# Access Compliance Report

## Public Rights-of-Way

### (Curb Ramps)

Intersection ID: 3648	Main Street: ARMITAGE_DR	Cross Street: WHITE_CASCADE_DR	Location: NE
ADA ID: A2A1FC174768	Ramp Type: Directional1	Initial Pass/Fail: Pass	Overall Compliance: No
		Severity Score: 2.5

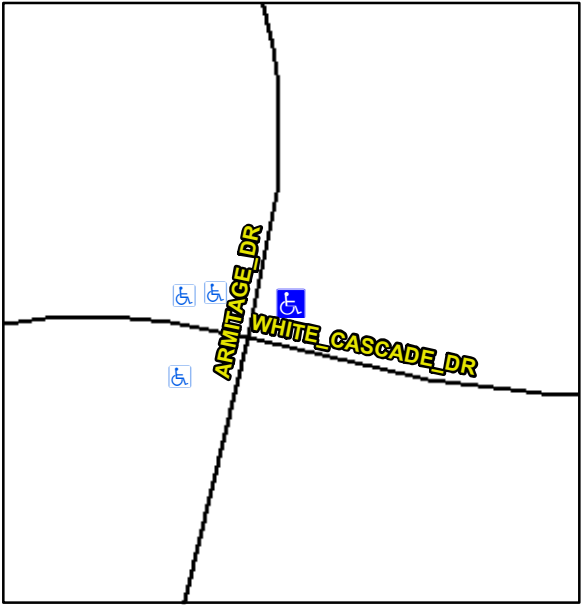
Codes/Mitigation Info/Possible Solution		Field Measurements/Component Compliance					
	Possible Solutions:						
	Remove & Replace Entire Ramp.						
	Surveyor Notes:						
	N/A						
	PROW/ADA:						
	Not Found, R304.2.1, R304.2.2-Perp, R304.3.2-Para, R304.5.3, R305.1.4, R305.2						
	Street 1 Name	ARMITAGE DR					
	Stop Condition-Street 1	StopSign					
	Street 2 Name	N/A					
	Stop Condition-Street 2	N/A					
Total Cost:		\$	1600.00				
		Compliance	Description	Data	Compliance	Description	Data
		N/A	Ramp Length (in)	36.0	Yes	Grade Break?	Yes
		Yes	Ramp Width (in)	48.0	No	Grade Break Slope (%)	6.2
		Yes	Ramp Slope (%)	3.0	No	Grade Break XSlope (%)	3.4
		Yes	Ramp XSlope (%)	1.2			
		N/A	Flare Type LT	N/A	N/A	Flare Type RT	N/A
		N/A	Flare Slope LT (%)	N/A	N/A	Flare Slope RT (%)	N/A
		N/A	Flare Traversable LT?	N/A	N/A	Flare Traversable RT?	N/A
		No	Landing Length (in)	47.0	Yes	DWS Provided?	Yes
		Yes	Landing Width (in)	48.0	Yes	DWS Contrast?	Yes

No	Landing Slope (%)	4.3	Yes	DWS Length (in)	25.0
		Yes	Landing X Slope (%)	0.6	No	DWS Full Width?	No
		N/A	Landing Curb? (Y/N)	No	Yes	DWS Offset LT (in)	50.5
		N/A	Shared Landing?	No	No	DWS Offset RT (in)	6.0
		Yes	Gutter Ponding?	No	Yes	Gutter Slope (%)	2.0
		Yes	Gutter Lip Ht (in)	0.0	Yes	Gutter X Slope (%)	1.5
		N/A	Painted X Walk1?	No		Road Slope (%)	3.5
			X Walk 1 Direction	To W		Road X Slope (%)	2.8
			X Walk 1 Width (in)	N/A		Clear Space?	Yes
			X Walk 1 Slope (%)	3.5	N/A	Clear Space to XWalk (in)	N/A
			X Walk 1 X Slope (%)	2.8	Yes	Storm Grate/Utility Hazard?	No
		N/A	Ramp inside XWalk1?	N/A		Storm Grate/Utility Type	
		Yes	Any Obstructions?	No			N/A
			Obstruction Type		Yes	Surface Condition? (G/P)	Good
				N/A	No	Curb Slope (%)	17.3
